# Review of the Diablo Canyon Probabilistic Risk Assessment

NUREG/CR-5726  
BNL-NUREG-52288

Manuscript Completed: September 1993  
Date Published: August 1994

Brookhaven National Laboratory  
Upton, NY 11973

**Figure 3.4.1 Annual Exceedance Frequency vs. Leak Rate for Westinghouse Plants with Four RCPs (lower bound, best estimate, upper bound) (Figure Taken from Reference 20).**

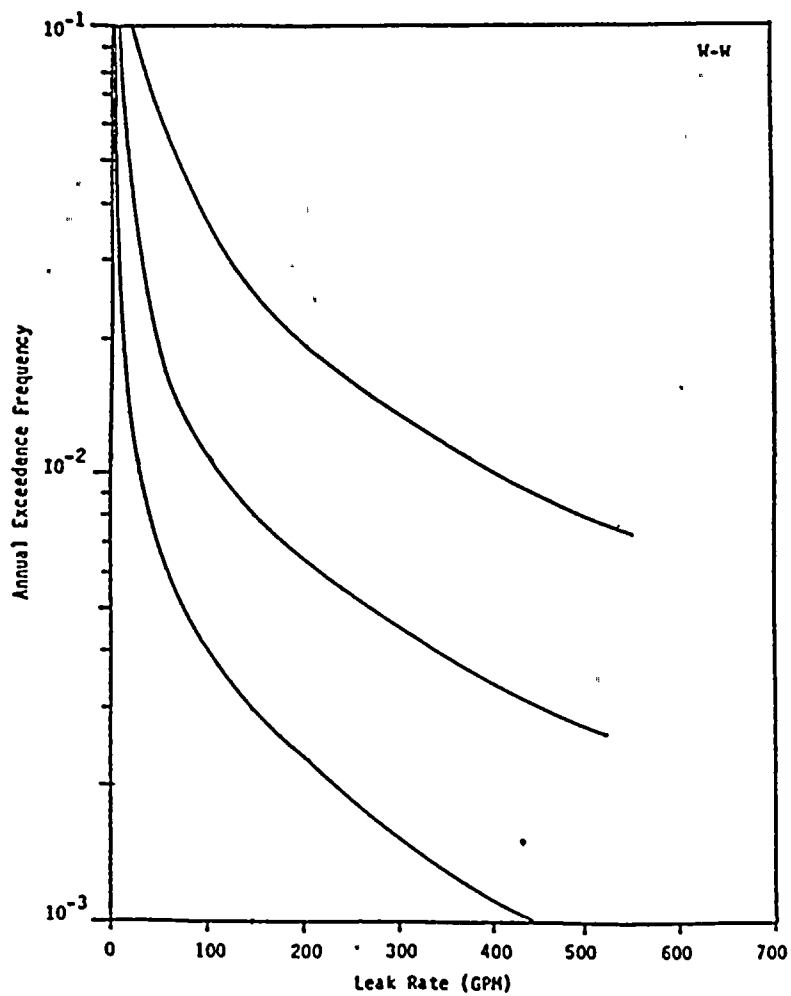
- e. The "Nonisolable, Small LOCA" initiating frequency seems to be underestimated from the point of view that industry-experienced RCP seal LOCA events caused by mechanical or maintenance-induced failures were neglected from the prior event sample. NUREG/CR-4400<sup>19</sup> identified 71 seal leakage events at Westinghouse RCP pumps up to 1985, with four events in the 25 gpm - 500 gpm leak rate range. Based on this information, an annual exceedance frequency vs. leak rate curve was constructed for Westinghouse plants with four RCPs (see Figure 3.4.1). From this curve the initiator frequency of seal LOCAs exceeding the makeup capability of a plant can be estimated. Taking the "best estimate" curve, the RCP seal LOCA initiating frequency, i.e., the frequency of seal leakage events exceeding 150 gpm can be determined. The value is about  $8.0E-03 \text{ yr}^{-1}$ . This value, which relates essentially to a subset of unisolable small LOCA initiating events is still higher than the "updated" DCPRA value, which is  $5.83E-03 \text{ yr}^{-1}$ .

Figure A3.2.2. Logic diagram for top events AW and TD - Auxiliary Feedwater System

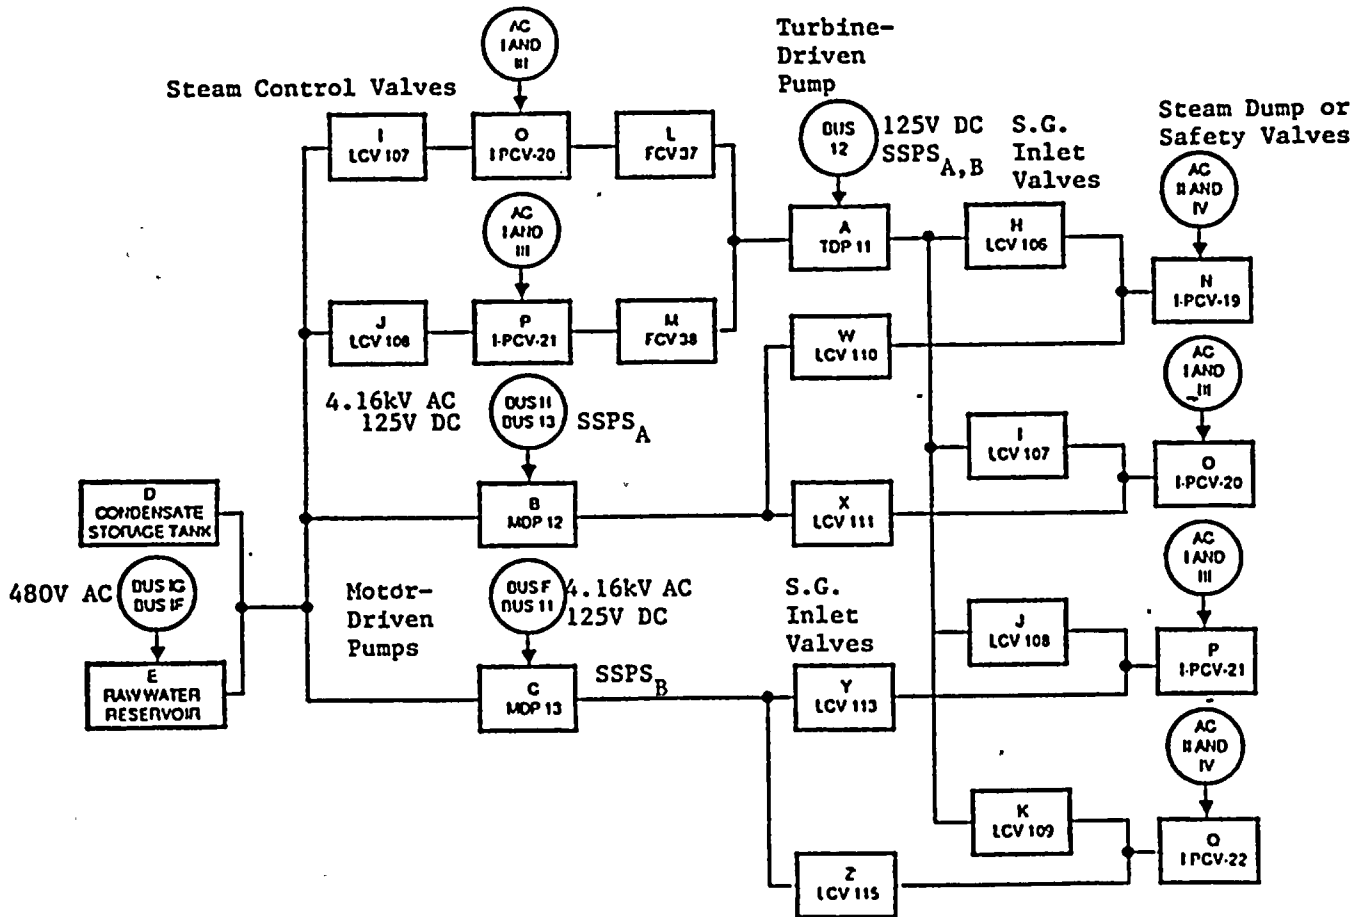
1. There was an apparent non-coherent condition in the AFW model (see also Comment No.1 in Table A3.2.3). A comparison of split fractions AW5 and AW7 with AW8 (as calculated by PG&E) shows that AW5 and AW7 have a higher unavailabilities than AW8, in spite of the fact that they involve less unavailable components than AW8. In the BNL calculations this inconsistency did not show up (see also Section A3.3.5).
2. In several cases there were some major or minor differences between the results of PG&E and BNL1.

Figure B5.3.1.a SSPS master fault tree for steam generator tube rupture initiator in DCPRA

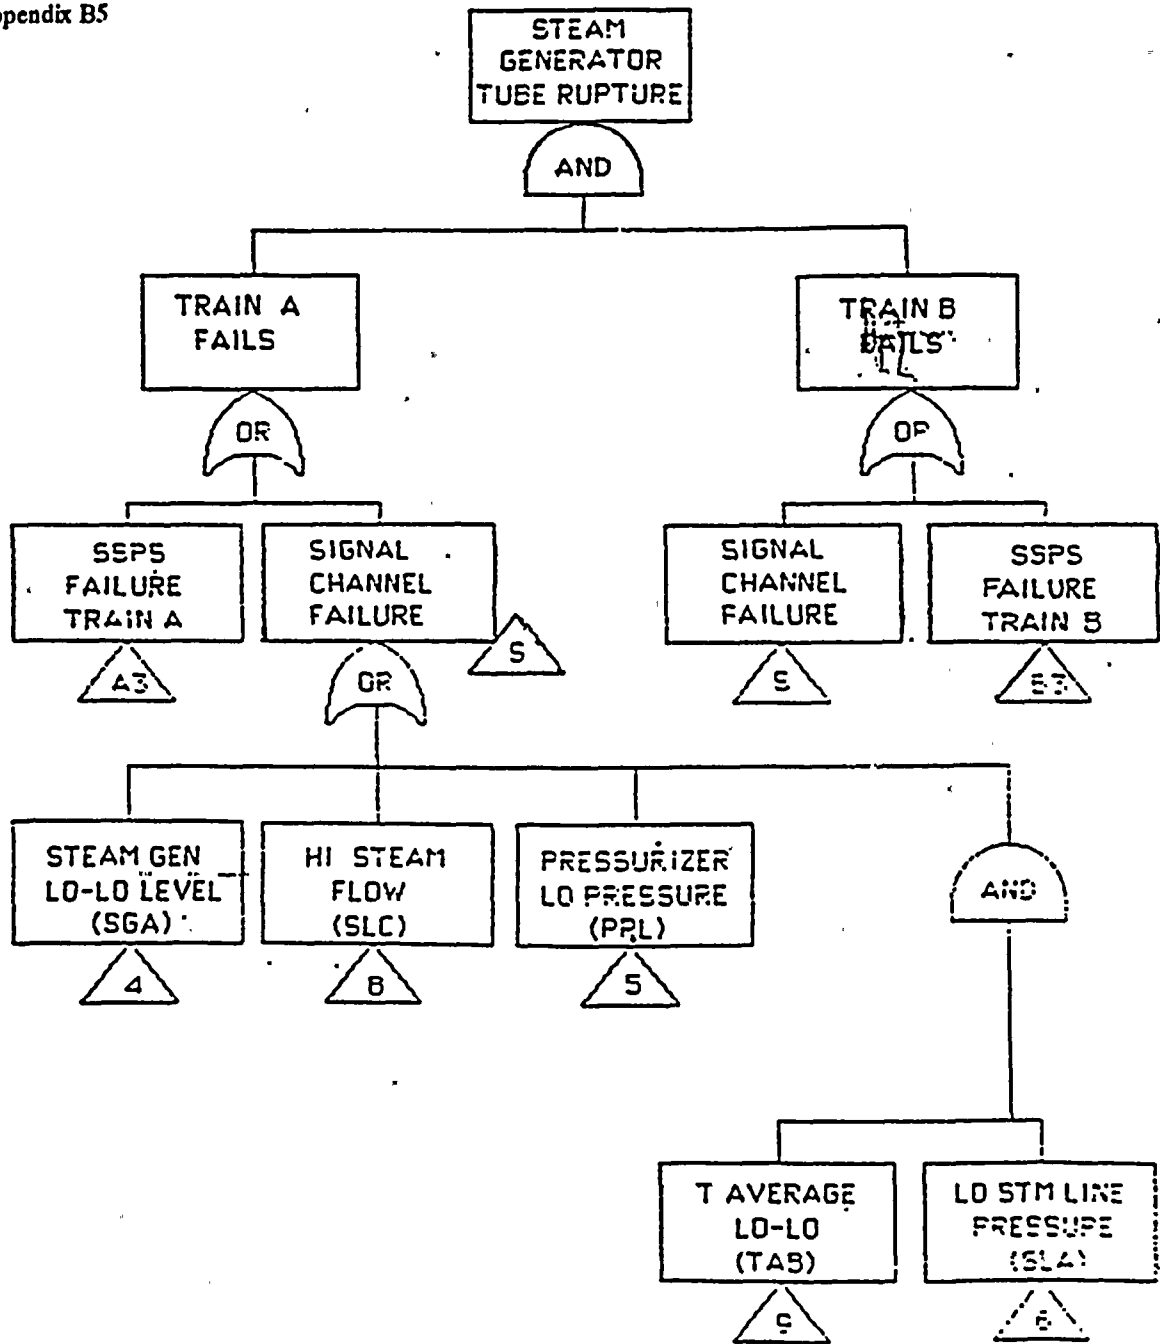
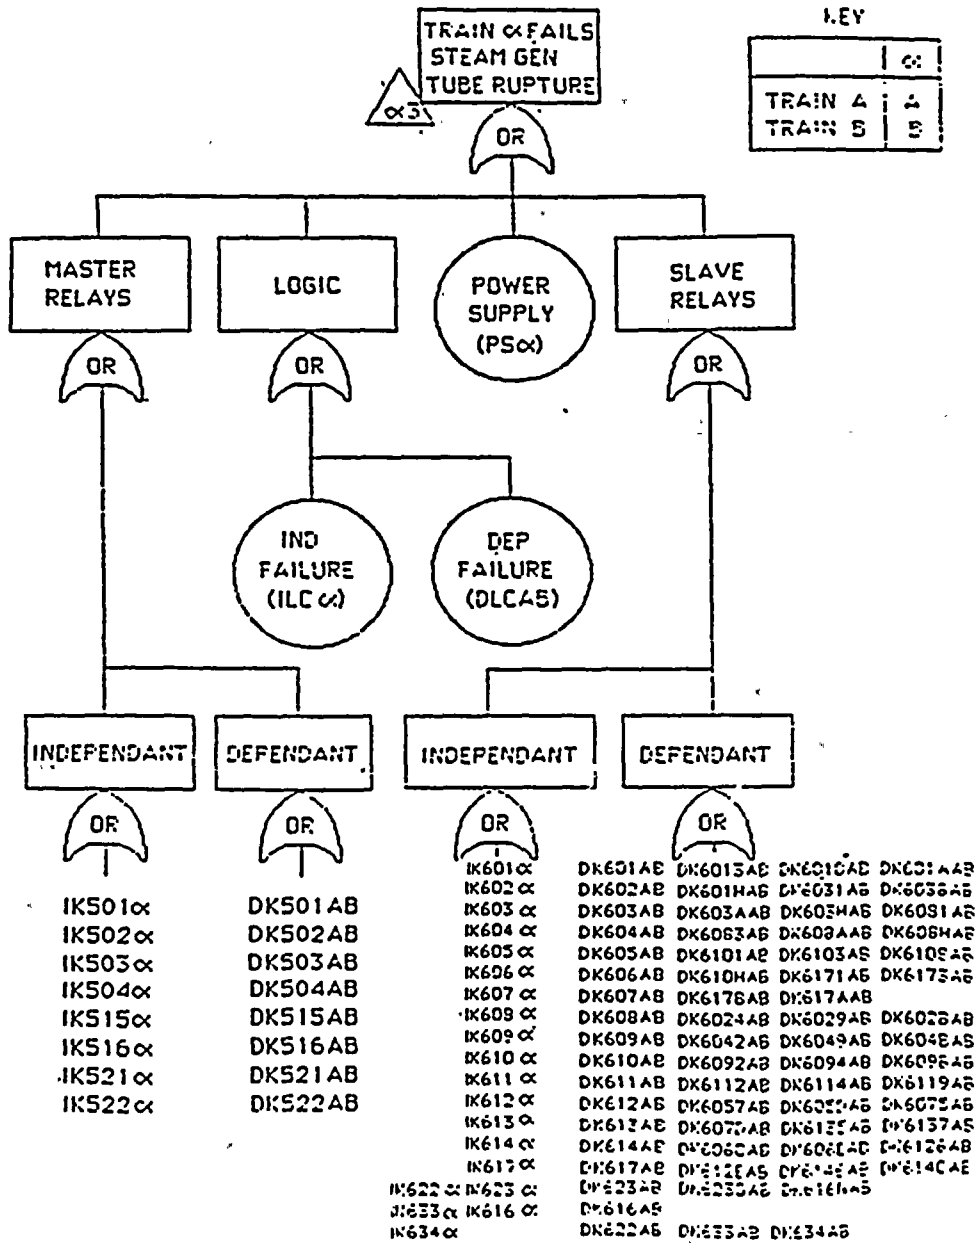
BNL believes the root cause of the discrepancy is that an oversimplified fault tree model was used for the SSPS in the DCPRA. In order to place this finding in perspective, BNL performed an importance analysis and a sensitivity study on the DCPRA reduced model provided by PG&E. The importance analysis showed that the contribution to core damage frequency (CDF) for system failure (both trains failing) was about 2% of the total non-seismic CDF and the sensitivity study showed that multiplying each of the SA split fractions by a factor of five and the SB split fractions by a factor of two increased the overall non-seismic CDF by 18%. BNL therefore believes this discrepancy does not have a significant impact on the DCPRA results, especially considering the modelling conservatisms discussed previously (e.g., a single signal failure fails a channel, etc.).
